SUBJECT: TURKEY POINT UNITS 3 AND 4 - ISSUANCE OF AMENDMENTS RE: BORIC ACID CONCENTRATION REDUCTION (TAC NOS. 79192 AND 79193)

UNITED STATES
NUCLEAR REGULATORY COMMISSION
WASHINGTON, D.C. 20555

ATTACHMENT TO LICENSE AMENDMENT

Figure 3.1.2.5

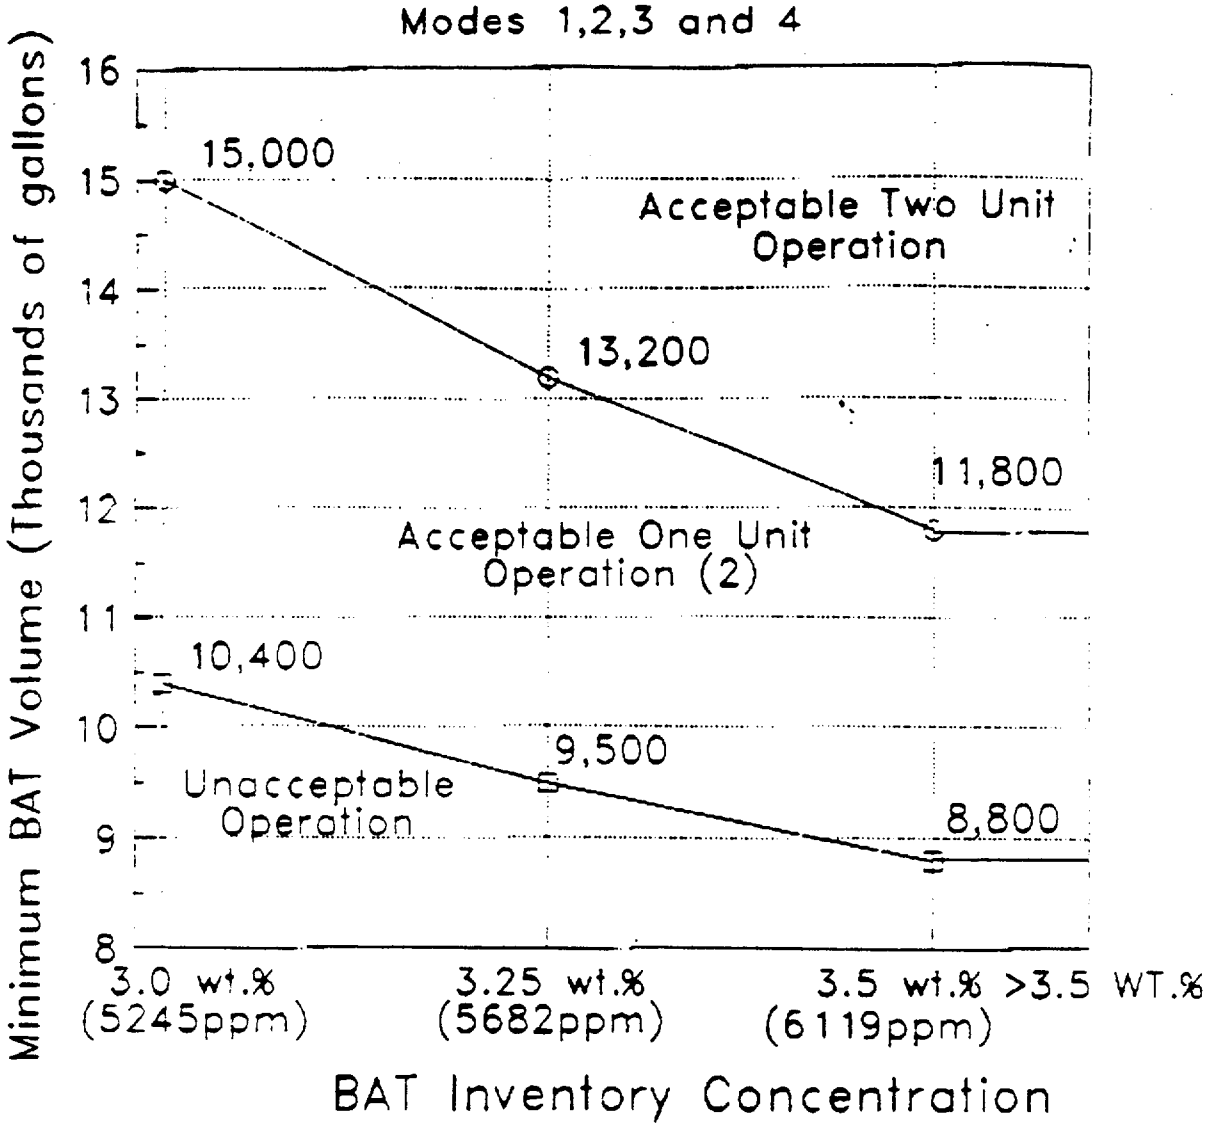
The planned reduction in BAT boron concentration (from 20,000 ppm-22,500 ppm boron to 3.0 wt% (5245 ppm) - 3.5 wt% (6119 ppm) (boron)) requires that all TS containing the current values be revised to reflect the new values. Similarly, the corresponding increase in delivery capacity from 4 gpm to 16 gpm (discussed in 2.2.2 above) requires the appropriate TS revisions. The following TS are affected by these changes: 3.1.1.1, 3.1.1.2, 4.1.2.2.c, 3.1.2.4.a.2, 3.9.1, 3.10.1 (a and b), 3.1.2.5.a (1 and 2), and the associated Bases sections. Figure 3.1.2.5 has been added to TS 3.1.2.5 to define the new BAT operability

requirements for volume and concentration. The volumes represented in the figure are the combined volumes of the three BATs, with allowance for minimum required volume for two operating units in Modes 1 through 4 and for one operating and one shutdown unit in Modes 5 and 6. For the shutdown unit, the minimum BAT volume required to provide a shutdown margin of 1% delta-k/k during cooldown from 200°F to refueling temperature, as specified in TS 3.1.2.4.a.1 (and associated Bases section) is changed from 500 gallons to 2900 gallons.

1) A minimum indicated borated water volume in accordance with Figure 3.1.2.5,

2) A boron concentration in accordance with Figure 3.1.2.5, and
